【Precaution】

DRAWING NO.	EDC-150989-91-21
PART NO.	FX8-40P-SV(91)
CODE NO.	CL578-0009-8-91

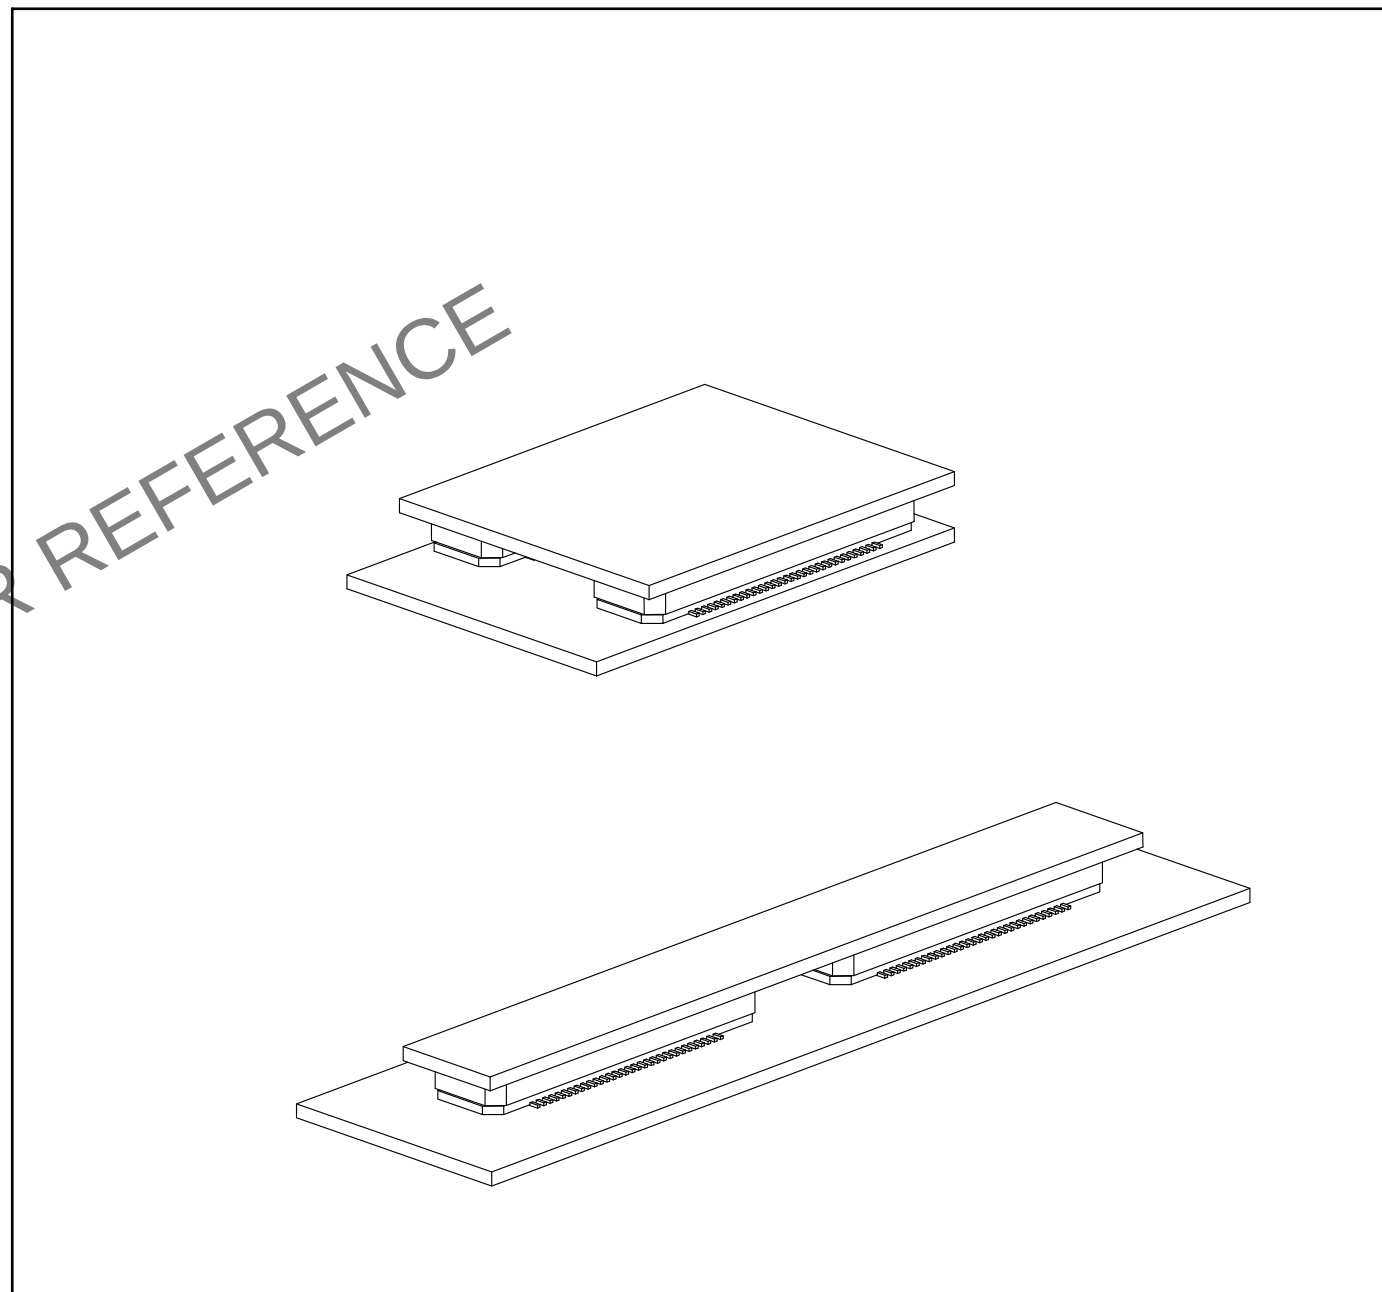
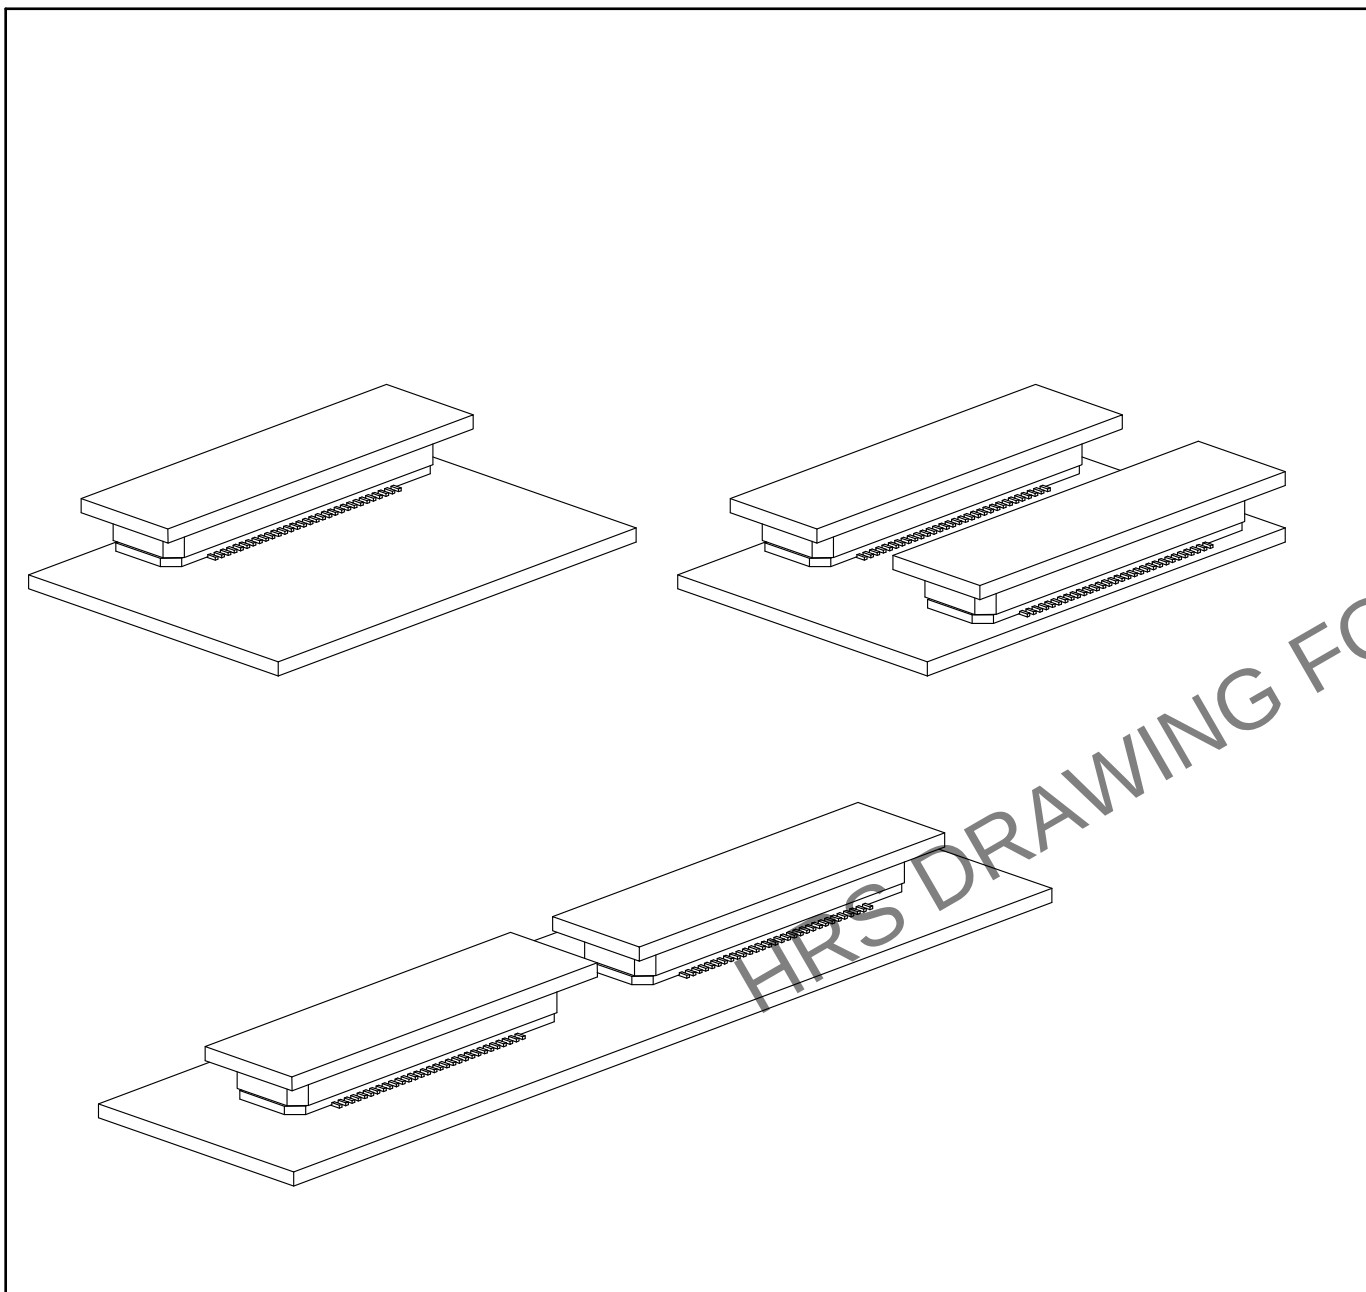
△¹ Added precaution

When a board with multiple connectors mounted is mated, the connector may be damaged or deformed.
Please divide one side of the board so only one connector is mated per board.
